Subject: AP1000 Response to Request for Additional Information (SRP 6)

AP1000 TECHNICAL REPORT REVIEW

RAI Response Number: RAI-SRP6.2.1.1-SPCV-07

Figure D-1

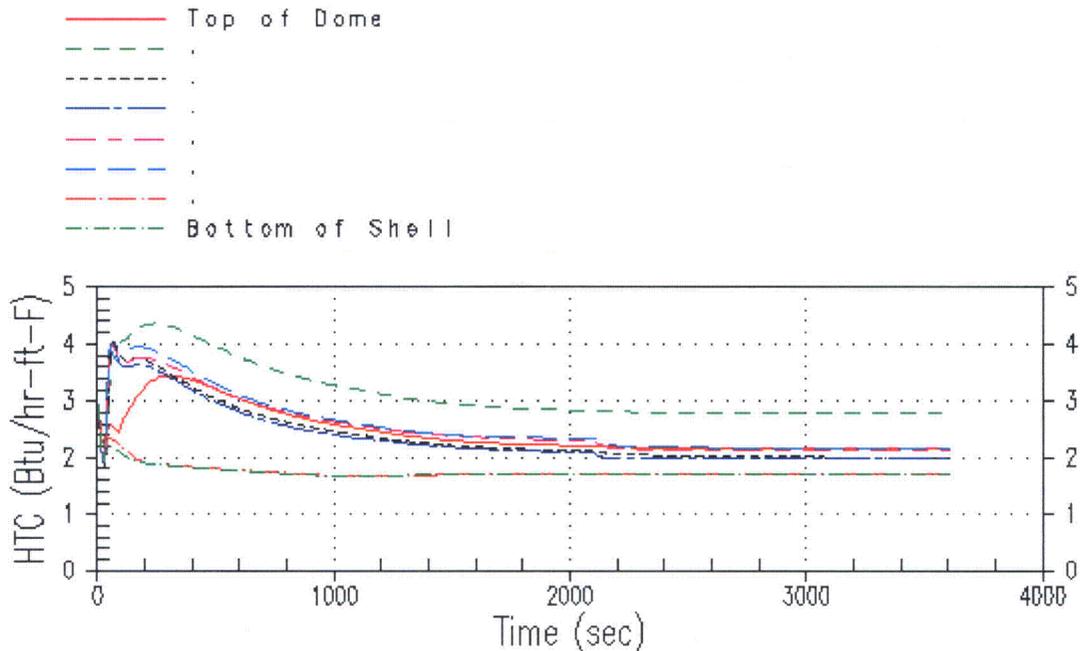
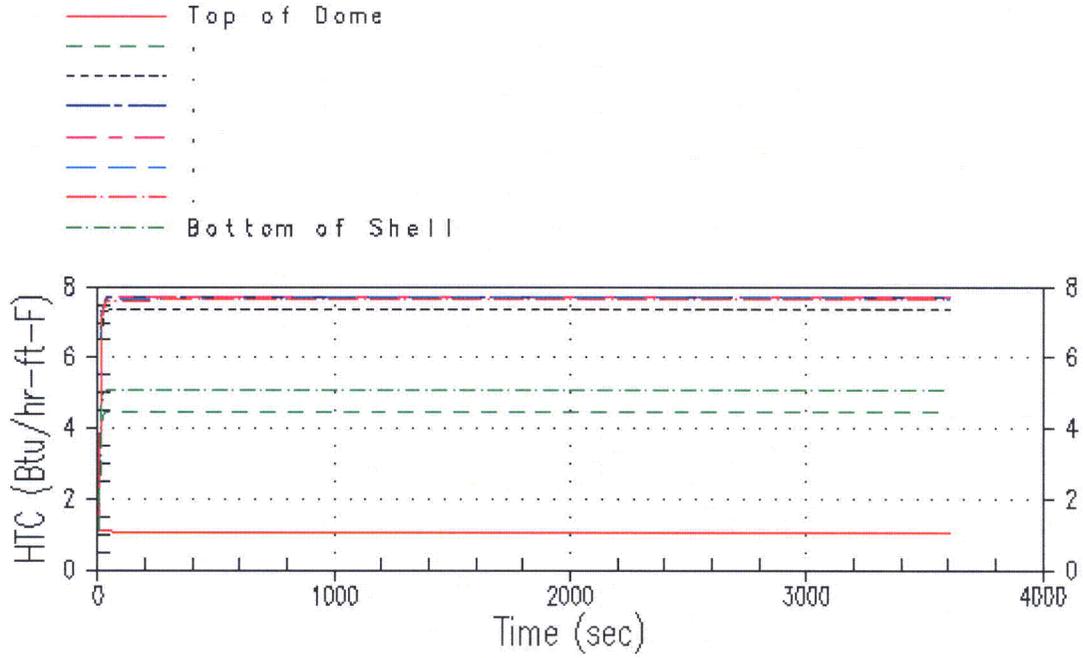
- d) In response to RAI-SRP6.2.1.1-SPCV-01 and -03, Westinghouse provided values calculated by WGOTHIC for the heat transfer coefficients of the containment shell, baffle, and shield building. Explain how these were derived (specific time point and WGOTHIC conductor) and why they differ from the heat transfer coefficients reported in the referenced calc notes (where at 3600 sec, h-outside containment shell =5.2 B/hr-ft²-°F and h-inside containment shell =1.6 B/hr-ft²-°F).

- d) The heat-transfer coefficients provided in the RAI responses were taken from different thermal conductors than the heat-transfer coefficients plotted in the calcnote. The heat transfer coefficients calculated by WGOthic for one "stack" of shell thermal conductors (PCS shell from the dome to the operating deck) from the steady-state run are presented in Table D-1. The heat transfer coefficients calculated by WGOthic for one stack during the transient are provided in Figures D-1 and D-2.

Table D-1
Heat Transfer Coefficients from the Steady State Run

Figure E-1

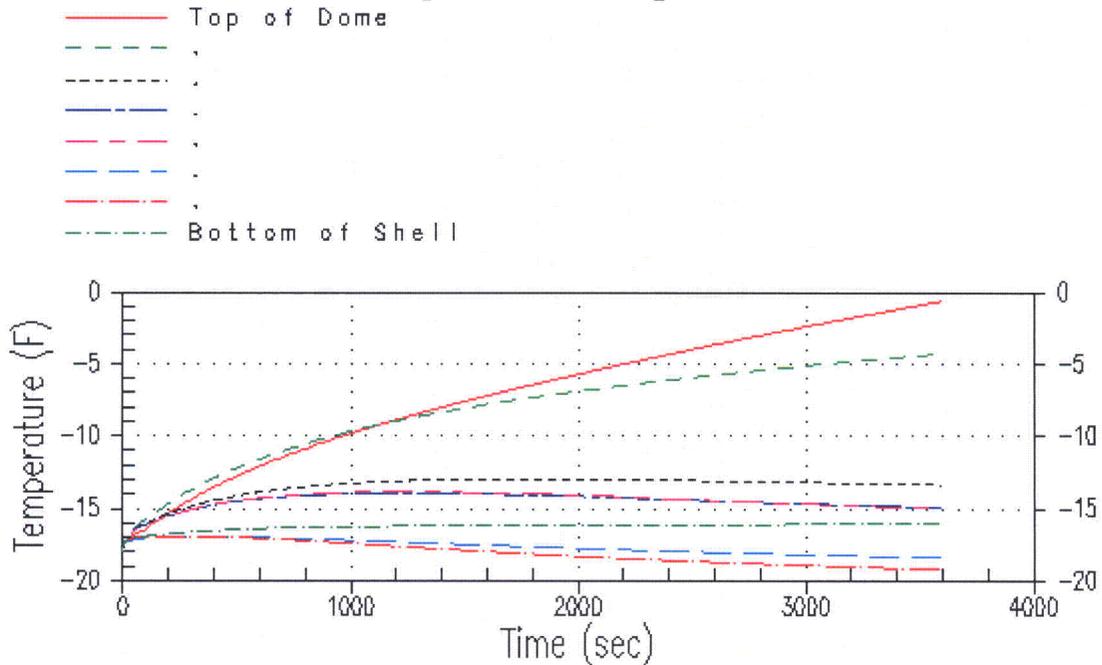
- e) Although the referenced calc-notes state that the containment shell temperature was initially set to -18°F for the second part of the analysis (actuation of fan coolers after steady state operation at low temperature), the WGOTHIC model included in the Appendix has the shell conductors set to 69°F. Please provide a plot of the containment shell temperature versus time for this transient.

- e) The containment shell initial temperatures were appropriately set to -18°F in the transient WGOthic run of APP-MV50-Z0C-020. The initial temperature was determined from a conservative estimate of the average temperature of the shell in the steady-state run. The temperature response of one PCS "stack" during the transient is provided in Figure E-1.

Figure F-1

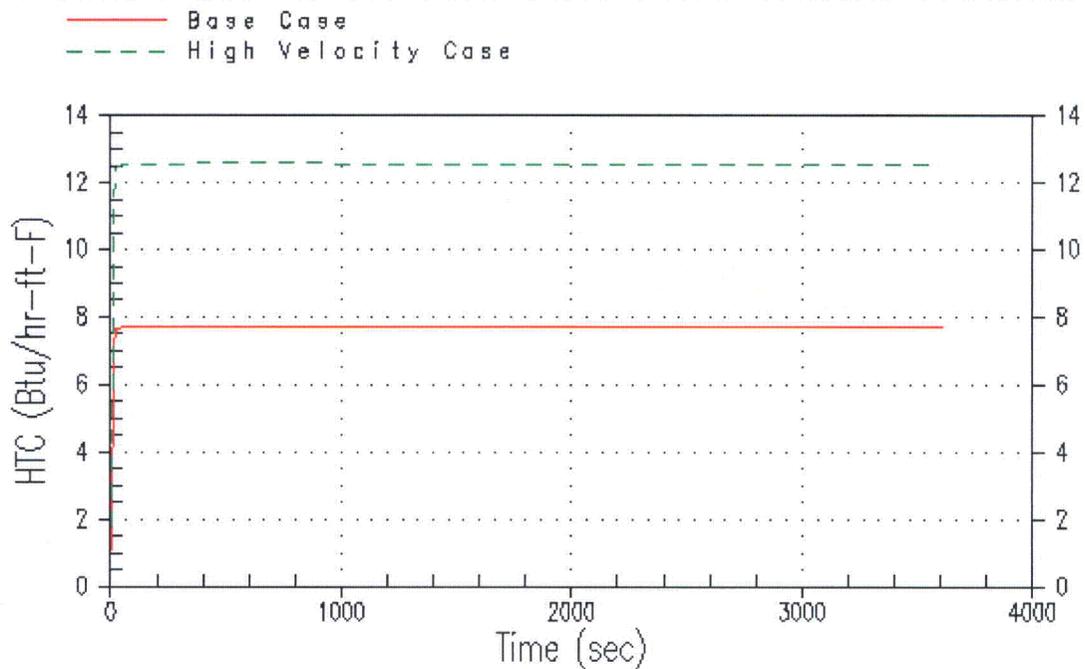
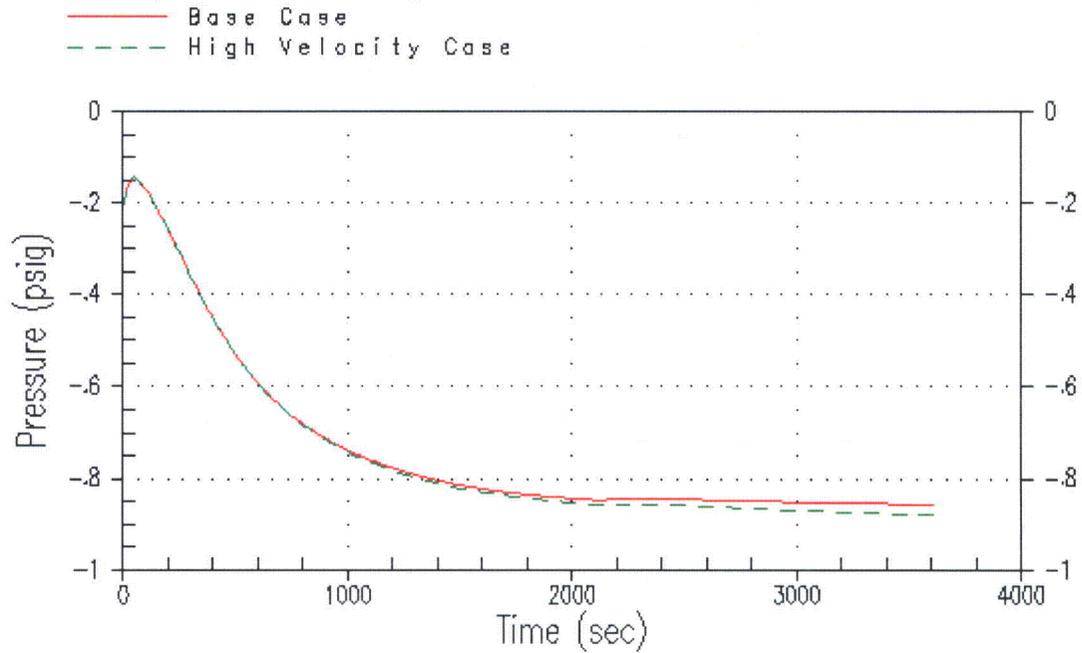
- f) In response to RAI SRP 6.2.1.1-SPCV-04, Westinghouse states that the changes to the shield building air inlets make the air velocity in the annulus less dependent on external wind speed. In the original design, the assumed 48 mph wind speed was modeled with a 25 mph annulus velocity. For the new shield building design, describe how annulus velocity was modeled and how this correlates to a 48 mph wind speed.

- f) The wind-induced annulus velocity does not have a significant impact on the calculation with respect to the annulus velocity induced by the gas-density difference in the PCS. In the APP-MV50-Z0C-020 analysis, WGOthic calculates the velocity through the annulus, which is 25 ft/s (17 mph), based on density differences. A sensitivity analysis was run increasing the heat-transfer coefficients in the PCS annulus by 1.62 in the transient pressure case. The Nusselt number is a function of the velocity (Reynold's number) raised to the 0.8 power, so the resulting heat-transfer coefficient corresponds to an annulus velocity of 36.8 ft/s (25 mph). The WGOthic heat-transfer coefficients on the outer shell surface increase as shown in Figure F-1. The impact on the peak external pressure is 0.024 psi (Figure F-2), which is a 3% increase in the external pressure.

Replace the current DCD Rev. 17 Figure 6.2.1.1-11 (shown here)

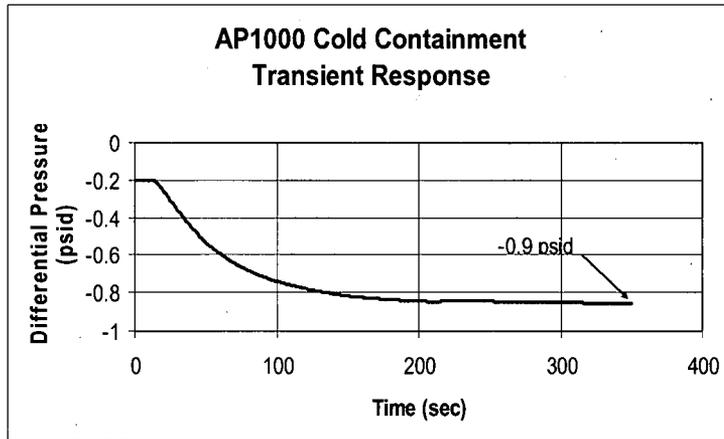
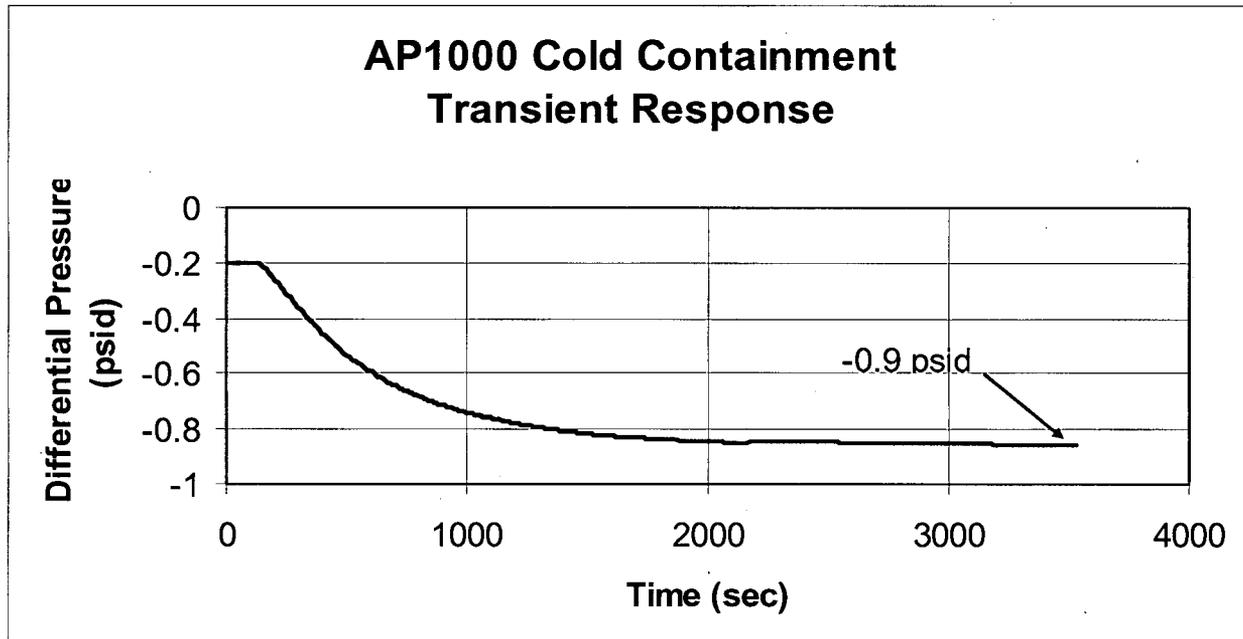
- c) There is a 10x difference in time scale between DCD Figure 6.2.1.1-11 and the associated data points from Appendix E of the referenced calc notes. Please resolve the discrepancy. If the scale in the DCD Figure is correct, justify why analysis ended after 6 minutes.

- c) The DCD figure 6.2.1.1-11 time scale is in error and should be corrected. See DCD revisions section below.

With this version:
